CIRCULAR LETTER 51/2007
6 June 2007

**REVISED SECTION B-400 OF THE
CHART SPECIFICATIONS OF THE IHO (M-4)**

Responses to CL 08/2007
Comments by Australia and Portugal

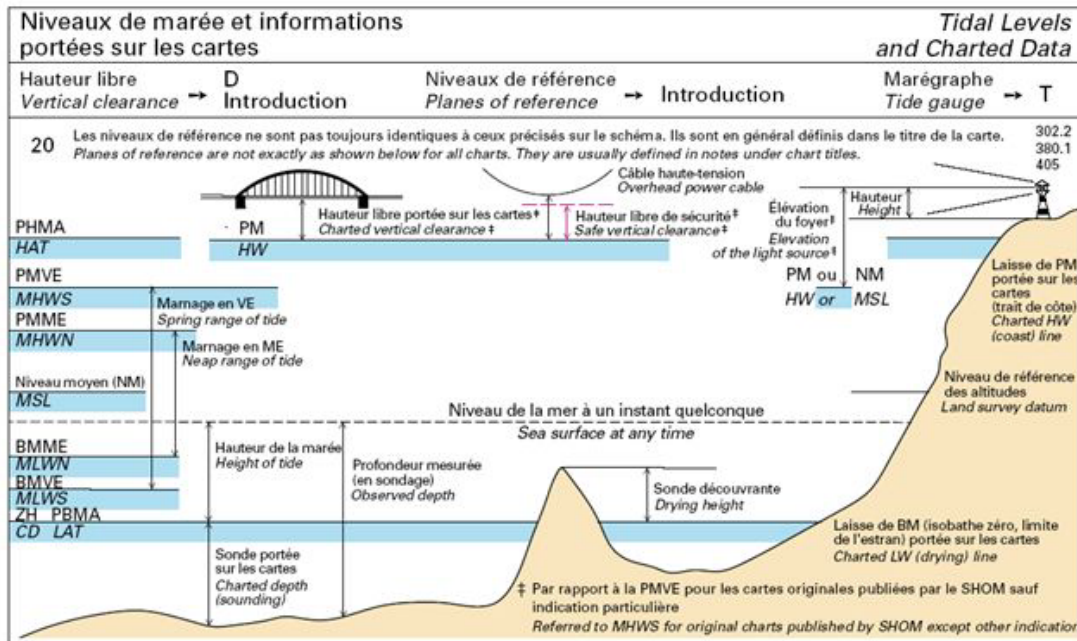
On the paragraph B-405 in the Chart Datum Scheme, the charted elevation is referred to the charted HW (coast line).

According to Technical Resolution A2.5 – “DATUMS AND BENCH MARKS

1.- It is resolved that heights on shore, including elevations of lights, should be referred to a HW datum or Mean Sea Level (MSL). The datum used should be clearly stated on all charts.”

Therefore, in the scheme (B-405) the relation between MSL and Charted Elevation should be represented.
